DAVIS-BESSE NUCLEAR POWER STATION, UNIT NO. 1

AMENDMENT TO FACILITY OPERATING LICENSE

Amendment No. 16
License No. NPF-3

ATTACHMENT TO LICENSE AMENDMENT NO. 16

Figure 2.1-2 Reactor Core Safety Limit

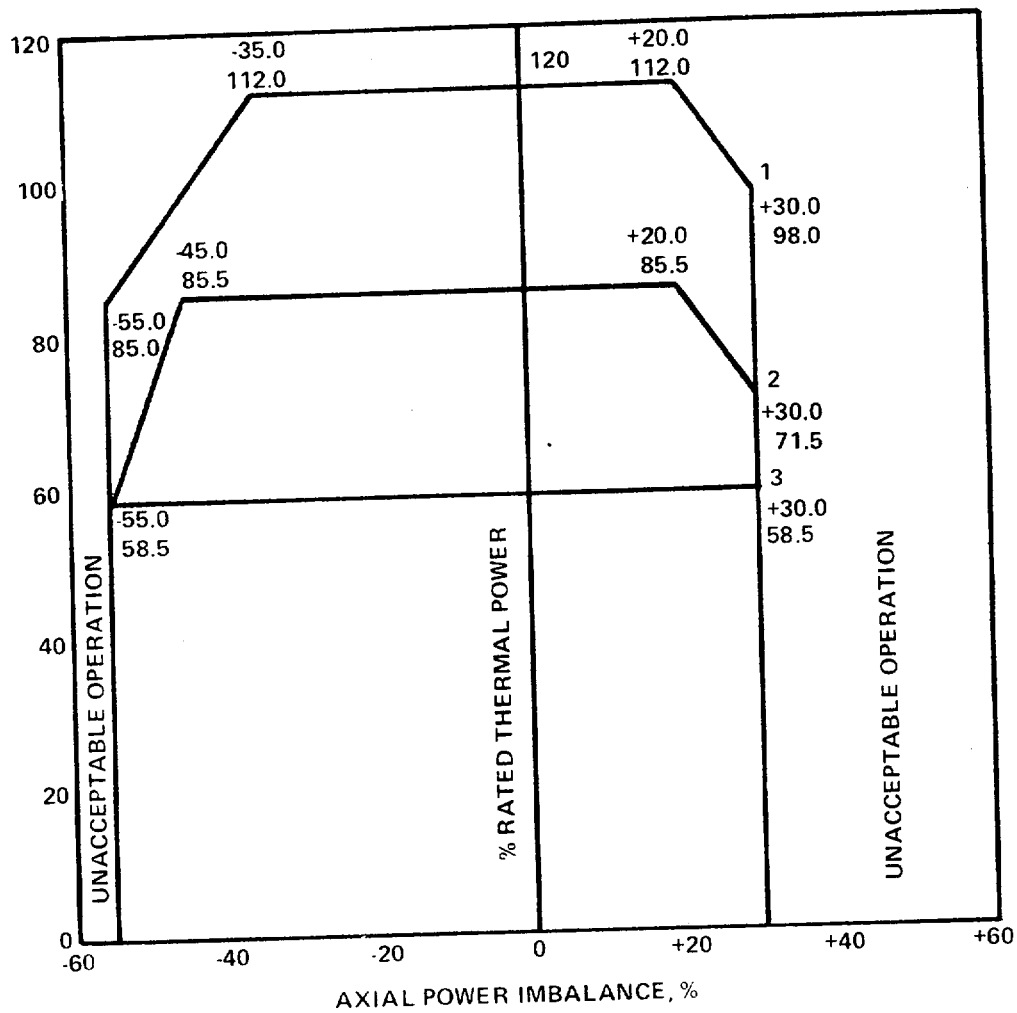
The amendment changes the Technical Specifications concerning the Reactor Core Safety Limit Curve, the Reactor Protection System Instrumentation Trip Setpoints and the maximum Reactor Coolant Hot Leg Temperature for departure from nucleate boiling margin. This amendment also makes minor editorial corrections to Technical Specification Figure 2.1-2 and Table 5.7-1. 7908090678

CURVE	REACTOR COOLANT FLOW (GPM)
1	387,200
2	290,100
3	191,000

Figure 2.2-1 Trip Setpoint for Flux- Δ Flux-Flow

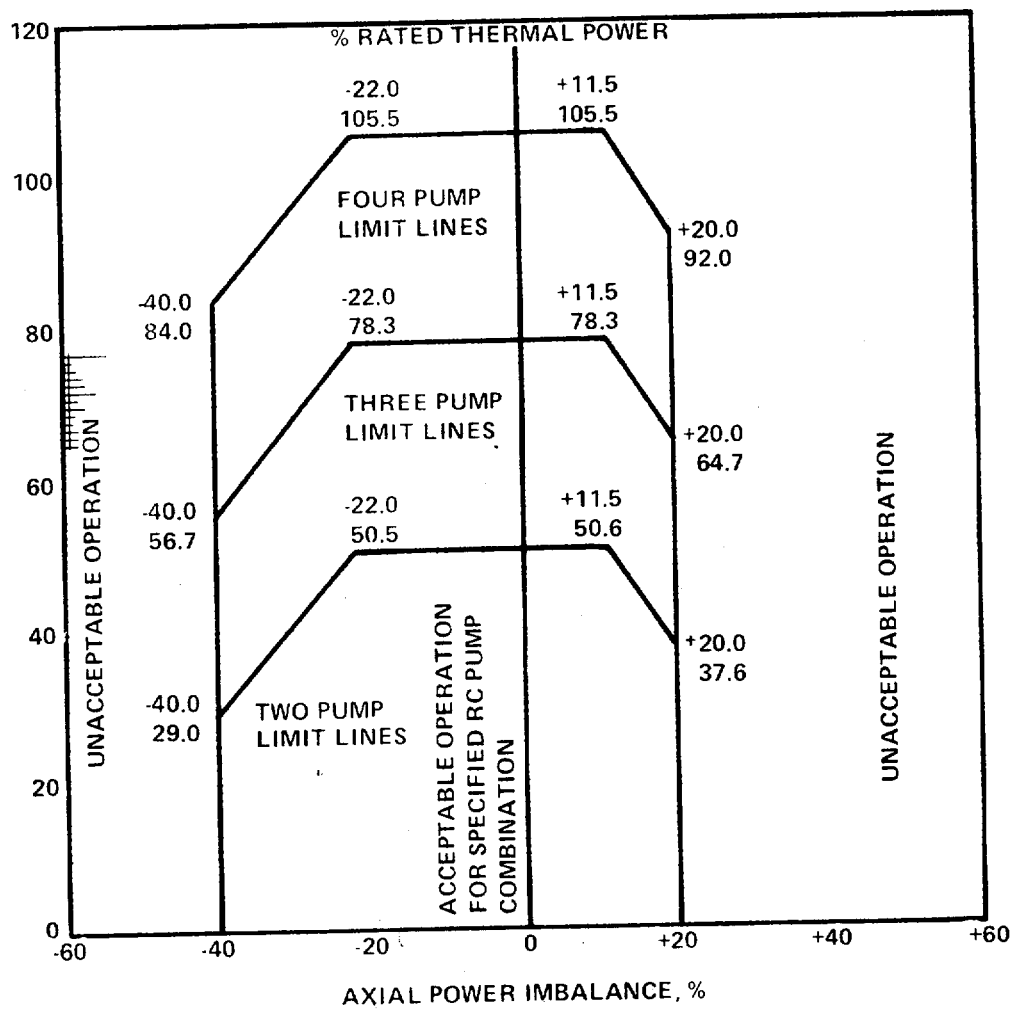
3. RC High Temperature	$\leq 619^{\circ}\text{F}$	$\leq 619.08^{\circ}\text{F}^{\#}$
4. Flux - Δ Flux-Flow ⁽¹⁾	Trip Setpoint not to exceed the limit line of Figure 2.2-1.	Allowable Values not to exceed the limit line of Figure 2.2-2. #

The AXIAL POWER IMBALANCE boundaries are established in order to prevent reactor thermal limits from being exceeded. These thermal limits are either power peaking kw/ft limits or DNBR limits. The AXIAL POWER IMBALANCE reduces the power level trip produced by a flux-to-flow ratio such that the boundaries of Figure 2.2-1 are produced.
